Evaluation Kit for RA2E1 Microcontroller Group
EK-RA2E1 v1
Errata

Renesas RA Family
RA2 Series

EK-RA2E1 v1 – Errata

Figure 1. MCU UID Leading Zero Not Displayed

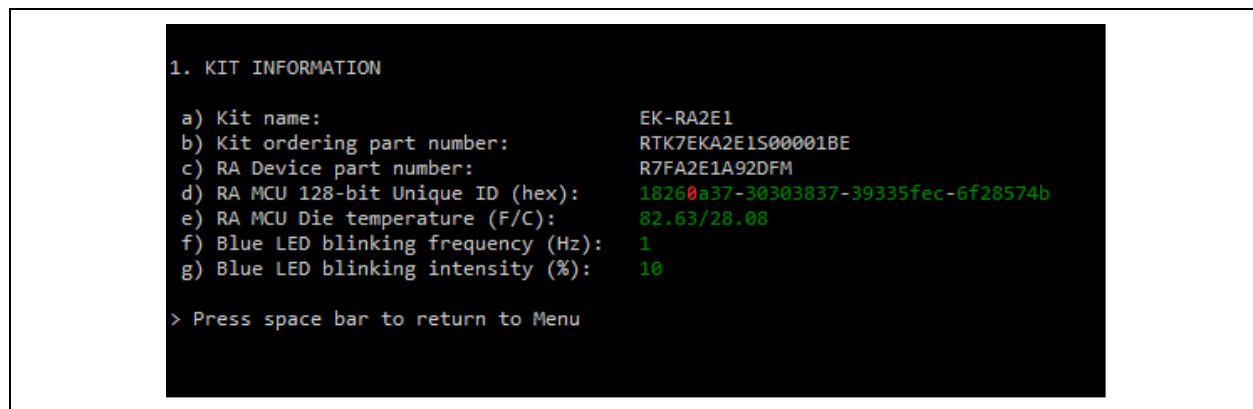
In certain cases the Quick Start Software programmed into the board may incorrectly display the device UID.

The UID is displayed in 'Kit Information' as a series of 4-byte values *bbbb-bbbb-bbbb-bbbb* as can be seen in the example below. If any single byte is of the form '0000nnnn', that is, has a leading zero, it will not be displayed.

The Quick Start Software programmed into later boards has been updated to show the correct device UID. The latest sample software can be downloaded from

Figure 2. MCU VCL Pin Capacitor Incorrect Value

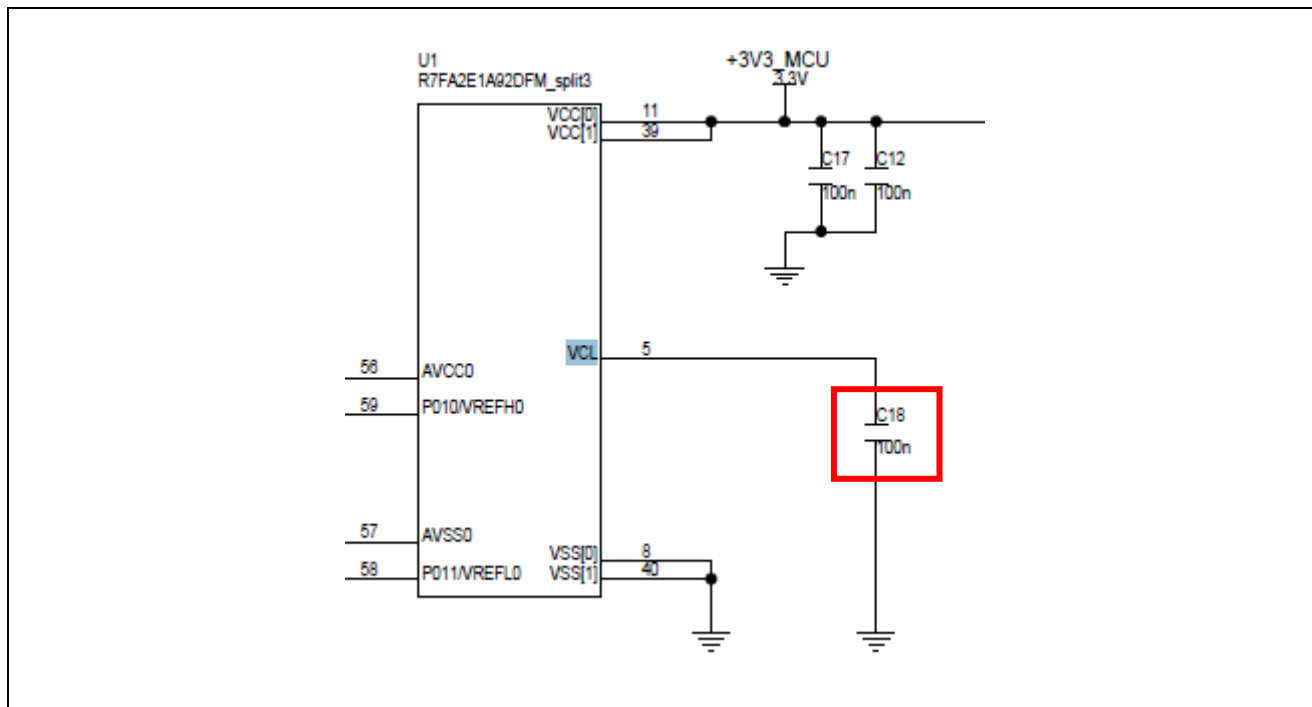
The VCL pin is used for stabilization of the MCU's internal operating voltage. The RA2E1 MCU hardware manual specifies that the VCL pin be connected to VSS using a 4.7 μF multilayer ceramic capacitor placed physically close to the pin. In earlier builds of the EK-RA2E1 board this capacitor (C18) has an incorrect value of 0.1 μF (100 nF).

It is recommended that you replace this capacitor with one with the correct value and type if mis-operation occurs when switching between low power and full power modes.

Figure 3. MCU Pin Header J2 Pin 8 Silkscreen Error

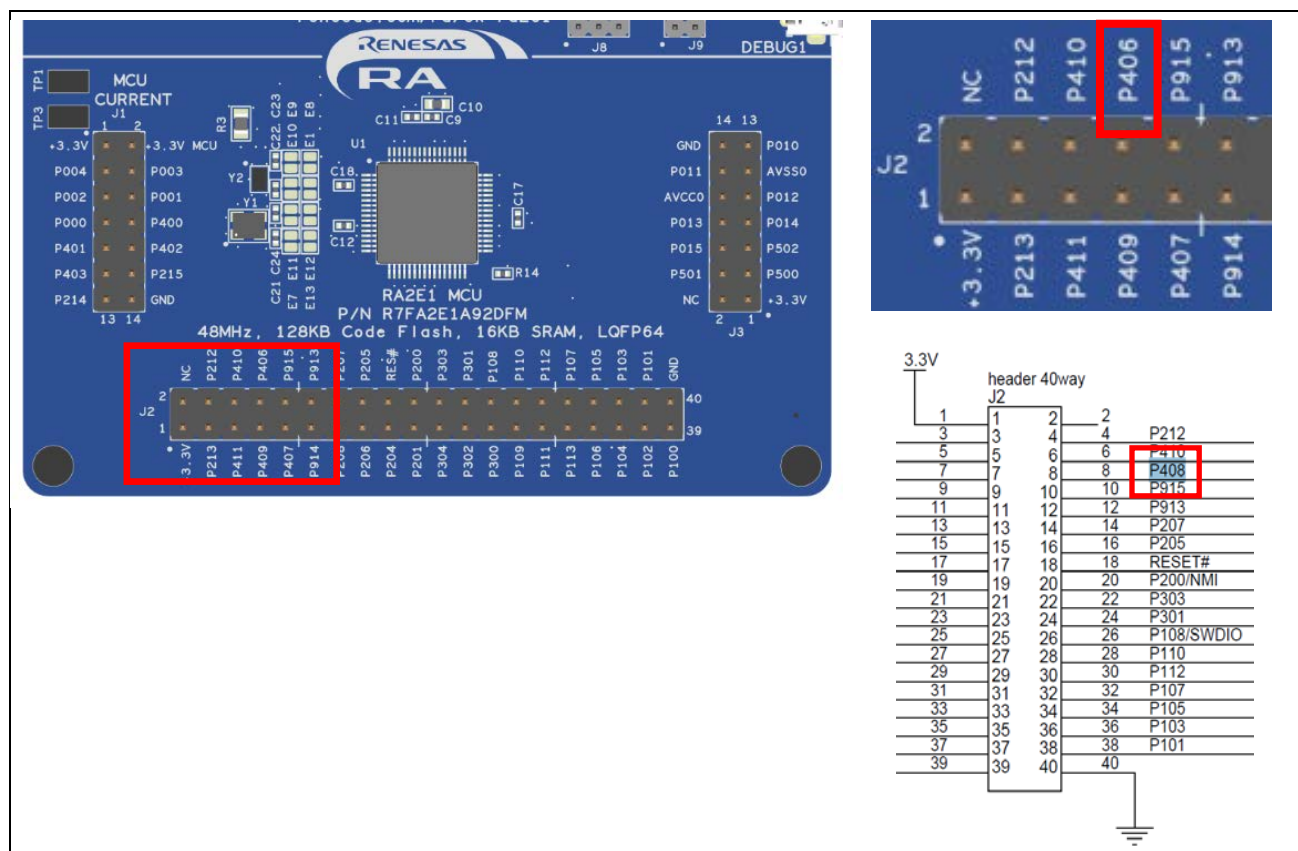
The MCU Pin Header J2 has an incorrect label for pin 8. This is identified as P406 when it should be P408. The schematic is correct.

None. The silkscreen has been corrected to show the correct pin identification on later builds of the board.
